Survey Results Summary

What do you think about the draft design concepts?

Hunsaker Lane	Comments
 <p style="text-align: center;">Rank your response to this design: <u>Majority voted "Support"</u> 1 = strongly against (3 votes), 2 = against (2 votes), 3 = neutral (3 votes), 4 = support (8 votes), 5 = strongly support (7 votes)</p>	<p>What's different about this design and why:</p> <p>Travel lanes have been reduced from 11 feet to 10 feet to slow vehicle speeds, with the goal being a posted speed of 25 mph instead of the current 35 mph</p> <p>Do you support this change? Yes <u>18 votes</u> No <u>8 votes</u></p> <p>The green space is 2 feet narrower to reduce the overall street width and minimize impacts to abutting properties.</p> <p>Do you support this change? Yes <u>22 votes</u> No <u>4 votes</u></p>
Beaver Street	Comments
<div style="display: flex; justify-content: space-between; margin-bottom: 5px;"> East Side of Street West Side </div>  <p style="text-align: center;">Rank your response to this design: <u>Majority voted "Strongly Support"</u> 1 = strongly against (0 votes), 2 = against (0 votes), 3 = neutral (1 vote), 4 = support (10 votes), 5 = strongly support (11 votes)</p>

Do you have any feedback on the proposed bike path location shown in red?

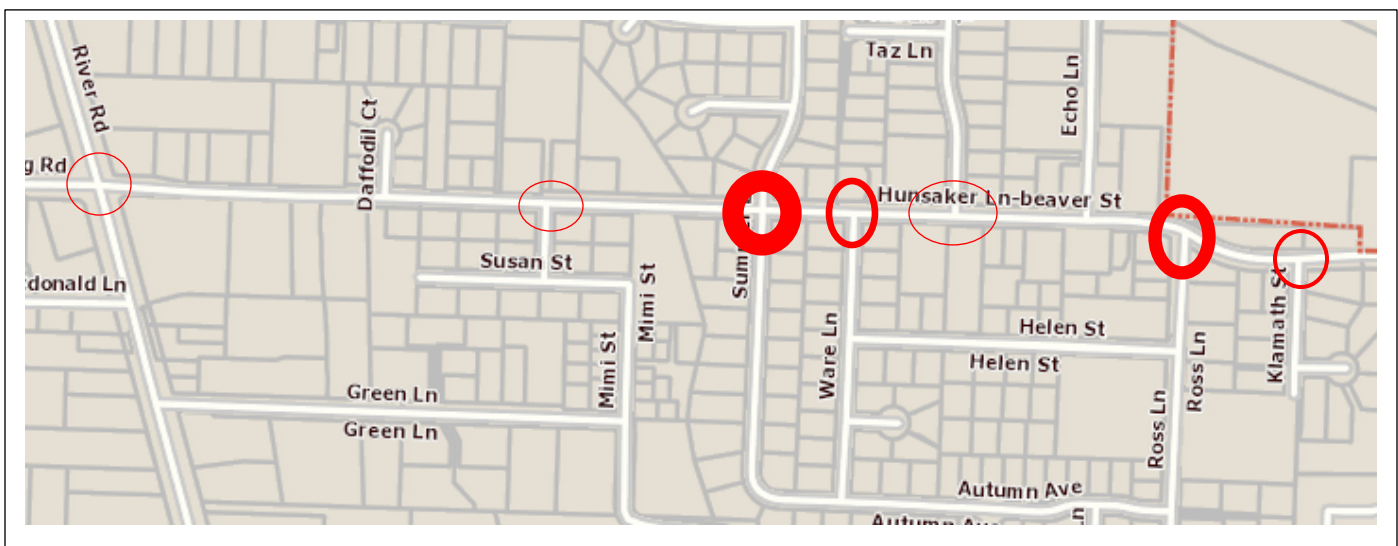
- Would be nice
- <none>
- We like that the proposed path connects to Madison Middle School and improves safety along Beaver-Hunsaker
- Too bad it's not for cars!!!

- Why not connect Hunsaker directly to Zane Lane/River Loop #1? Or if this version, why not Admiral Street to Alameda Street? Students & bikers currently use the driveway past the school's football field – only cars use the driveway into the school's parking lot. Also, the driveway past the football field is the direct route to the proposed Madison community park.

- I do like this idea for all bike riders.
- Great idea for biking and extension of west bank bike path. Keeps cyclists/peds off River Road connector.
- Looks great, but straighter is better. Why no use Alameda?

- Good
- I am in favor of this proposed bike path
- Looks good. See about bending it around the back of the 4J property to allow a straight line up Zane or make it go up Alameda & improve that crossing.

- I'll look forward to exploring it, if I'm not too old by then
- Will you put a fence between the path and adjoining private property?
- I support it but improving the roadway is my 1st priority

- Looks Good!
- Multi-use path ok. Needs to be dedicated bike/ped use.
- I love it. The neighbors at the southern tip of Admiral Street are concerned about kids on bikes at the intersection of Admiral and River Loop 1.

- No, only concern is the amount of use it will get from the present neighborhood
- The proposed bike path would make it the best logical solution to the excessive traffic on Hunsaker.

- My husband and I are in full support of the bike path project. We are active individuals that would utilize that space weekly. We also hope that the City of Eugene will prioritize a River Road project such as this. It's the equitable choice.

- I support but take another look at extending Beaver north to connect to River Loop 1 to reduce traffic on Hunsaker
- I like it. Path or bike lane needs to extend down Hunsaker to River Road.
